Consumers Power Company
Big Rock Point Plant
Docket 50-155

PROPOSED TECHNICAL SPECIFICATIONS PAGE CHANGES

August 5, 1985

Figure 6.2-2

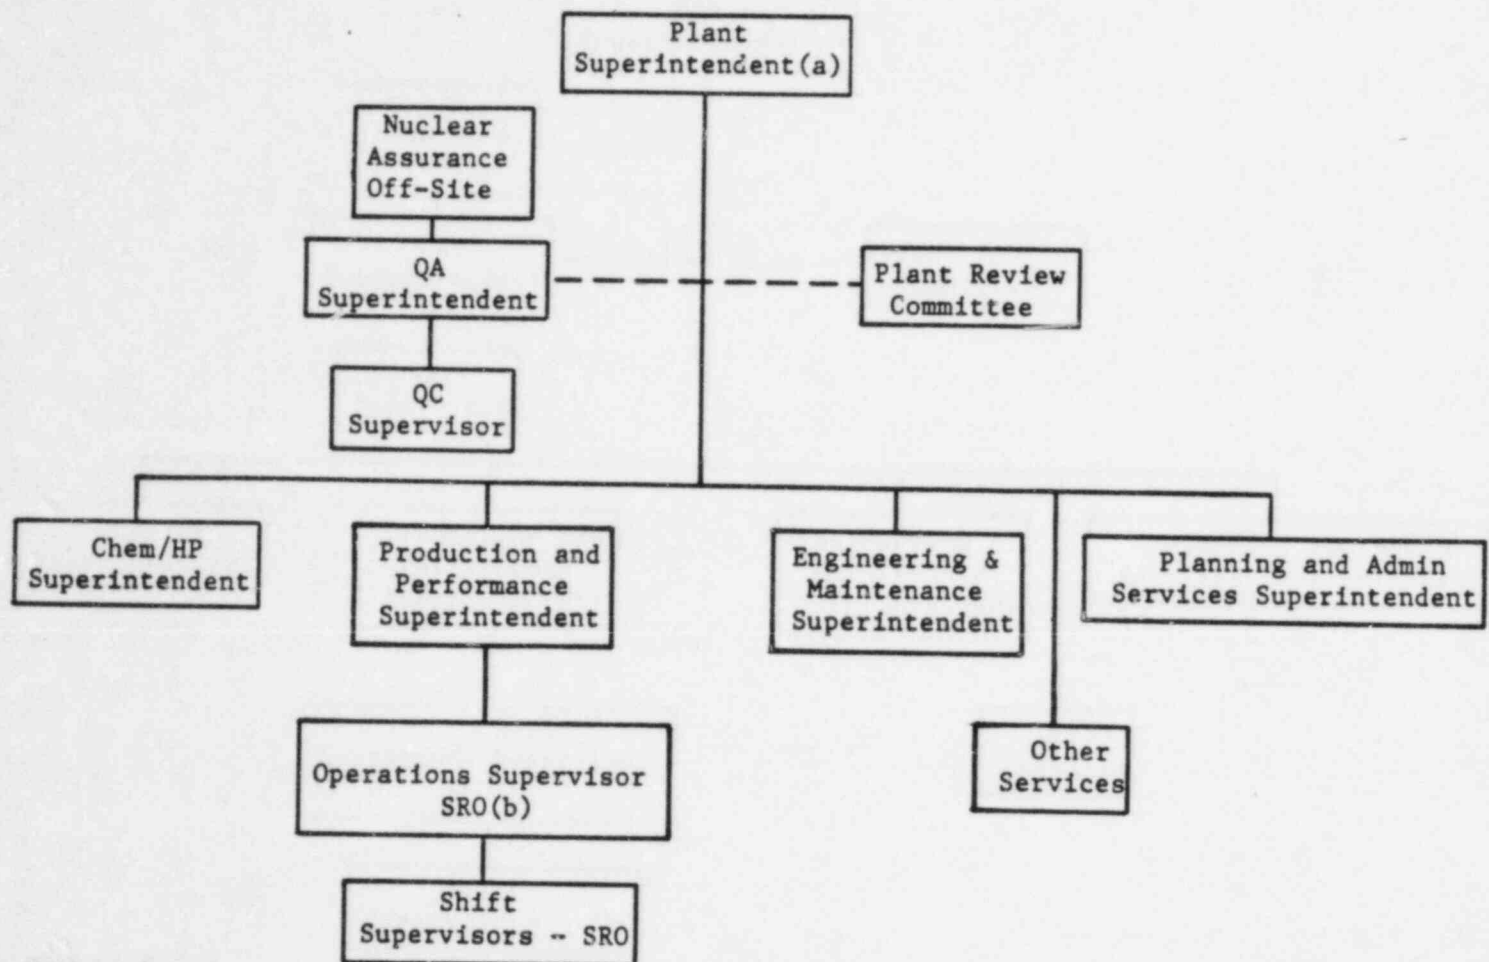
(a) Responsible for the Plant Fire Protection Program implementation.

(b) Either the Production and Performance Superintendent or the Operations Supervisor will hold an SRO and meet the other requirements of 6.3.1 of these Technical Specifications (as applicable to Operations Manager in ANSI N18.1). The individual holding an SRO shall be responsible for directing the activities of licensed operators.

A. To support the above Plant organization, personnel knowledgeable in the following areas identified in ANSI N18.7-1976/ ANS 3.2 will report at the discretion of the Plant Superintendent:

1. Nuclear Power Plant Mechanical, Electrical and Electronic Systems
2. Nuclear Engineering
3. Chemistry and Radiochemistry
4. Radiation Protection (Reports to Chem/HP Superintendent)

A single individual may be qualified and perform in more than one discipline.

B. The Security Force will be supervised as described in the Plant Security Plan.

C. Quality Assurance/Control activities will be in accordance with Consumers Power Company's Quality Assurance Program Description for Operational Nuclear Power Plants (CPC-2A, as revised).
